AMBLER BOROUGH PLANNING COMMISSION

1. Review "220 S. Chestnut Street Sketch Plan" proposing to demolition an existing warehouse / industrial building to construct 16 stacked townhomes Parking is provided in the rear of the buildings with access to Maple Avenue. Recommendation requested from the applicant.

Re: 220 South Chestnut Street, Ambler Borough, Montgomery County, PA, being Tax Parcel No. 25-0054-001 (the "Property")

To that end, enclosed is a revised Sketch Plan, prepared by the Applicant's Engineer, Protract Engineering, Inc. last revised April 14, 2025 (the "**Revised Plan**"). Some key changes and clarifications are outlined below.

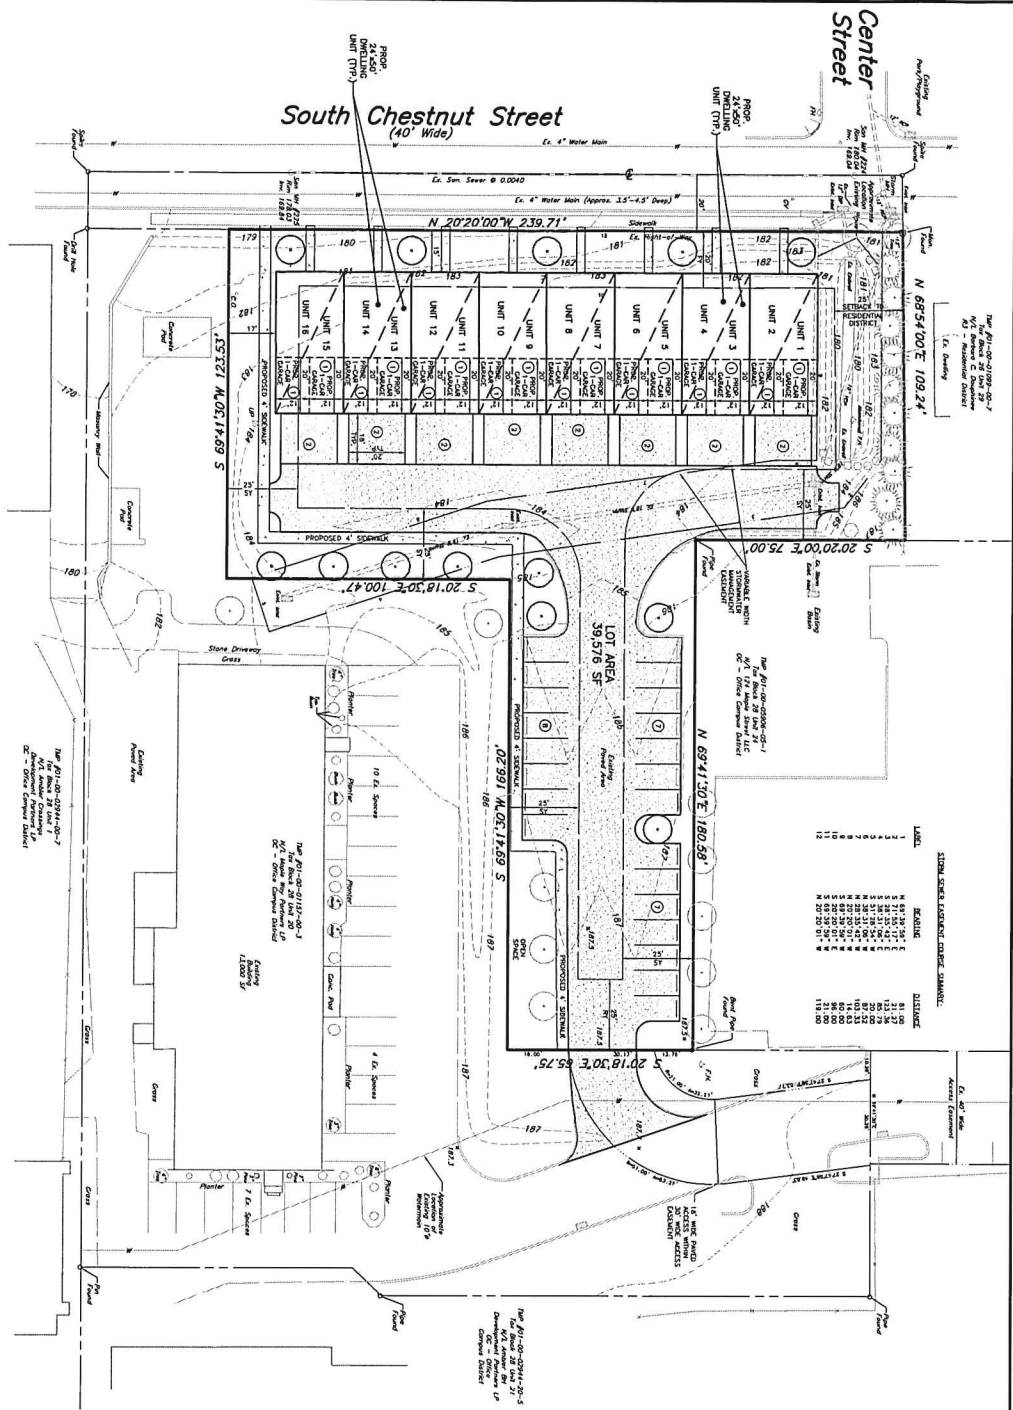
To this point, as was presented at the March PC Meeting and as depicted in the below aerial photograph, the Property is located between high density apartment uses, and a mix of detached and attached single-family homes. Thus, the Proposed Project does not just add a new product

offering to the Borough in general, it provides for a better product offering and transition of uses in the area of the Property.
